DOCUMENT CHANGE REQUEST

DCR number 117 Changes required for: N/A

Title: Resistors Heaters Flexible Single and Double Layer, Follow-up Specification for ESA/SCC Detail

Number: 4009/002

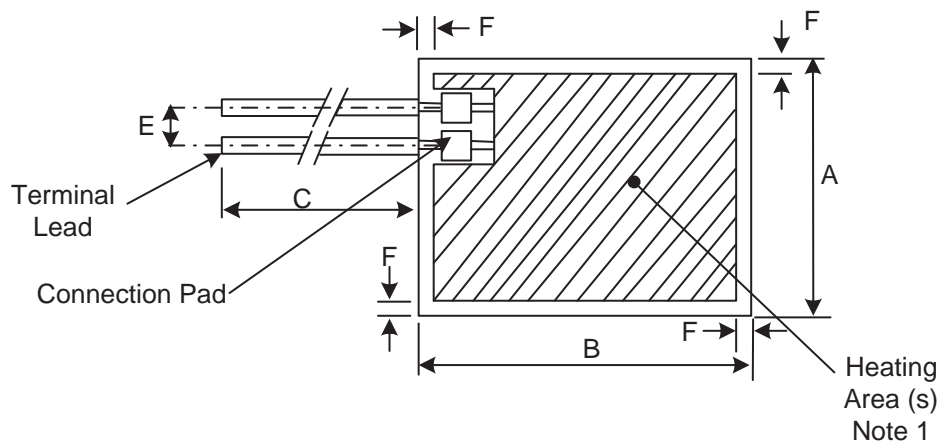
- 1) Rewording and restructure of various sections of the specification - for the purposes of simplicity, consistency and clarification.
- 2) Addition in para 2 and para 4.4.2 of applicable document ASTM-D5213 which supersedes the obsolete MIL-P-46112.
- 3) Deletion of any redundant paragraphs and text. e.g. Functional diagram, Parameter derating figures, electrical test circuits, burn-in circuit figure, etc.
- 4) Clarification in Max ratings Table 1(b) and Dimensions Figure 2, of the definition of heating area (s) (to exclude the

5) Delete dimension 'D' requirement and add notes to Figure 2 to allow terminal leads to exit the terminal connection area at any angle, plus define the lead spacing (Dim. 'E') to be measured at the terminal connection area. The position of the connection pads, and hence leads, is now only limited by the peripheral margin (Dim. 'F'). The new RICA/Nicolitch lead attachment process allows more flexibility in the positioning and aspect of the terminal leads whilst maintaining mechanical and material integrity.

Symbol	Millimeters		Tolerances (± mm)	Remarks
	Min.	Max.		
A	6	590	0.5	Note 1
B	8	600	0.5	Note 1
C	300	-	Note 2	-
E	2	-	Note 3	Note 4
F	0.4	-	-	Note 5, 6
s	-	-	-	Note 1

2. The tolerance shall be $\pm 10\%$ on the required dimension.
3. The tolerance shall be $\pm 0.5\text{mm}$ on the required dimension.
4. Terminal lead spacing shall be measured at the terminal connection area. Terminal leads may exit the terminal connection area at any angle. The terminal leads may be located on any side of the heater. There may be more than 2 terminal leads (for multiple resistive element and double layer heaters).
5. Peripheral margin dimension of the finished product.
6. Perforated holes in the peripheral margin are allowed provided that the distance between the edge of hole and the heater element or connection pad is equal to, or greater than, dimension F.
